June 28, 2011  
U7-C-NINA-NRC-110087

South Texas Project  
Units 3 and 4  
Docket Nos. 52-012 and 52-013  
Supplemental Response to Request for Additional Information

RAI 03.08.04-30, Supplement 4  
RAI 03.08.04-35, Revision 1

Figure 03.08.04-30 S4.1: Plan View of UHS Basin with Column Boundary Conditions Labeled

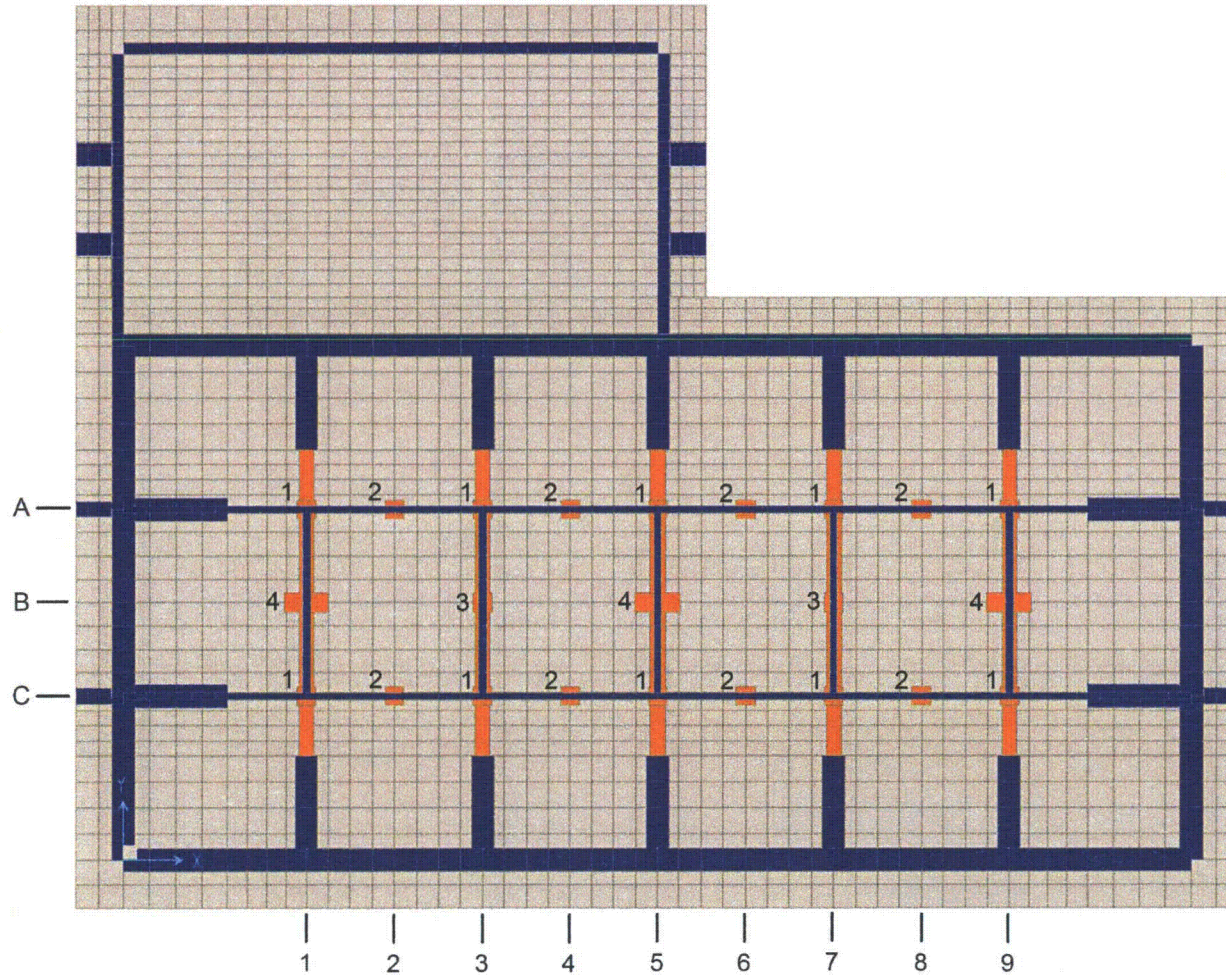
- a. *Determine column accelerations for column mass and hydrodynamic mass based on column frequency and spectra at top and bottom of the columns and revise RAI 03.08.04-30, supplement 1 to report new information (Audit Action Item 3.7-15, Punch List Item 17)*

Based on column size and boundary conditions at the top and bottom supports, the UHS basin columns are idealized considering the following four column configurations:

1. 5x5 Column\_BotFix\_TopFixX\_TopFixY
2. 5x5 Column\_BotFix\_TopFixX\_TopPinY
3. 5x5 Column\_BotFix\_TopPinX\_TopFixY
4. 5x12 Column\_BotFix\_TopPinX\_TopPinY

Figure 03.08.04-30 S4.1 shows a plan view of the UHS basin with the column configuration type labeled for each column.
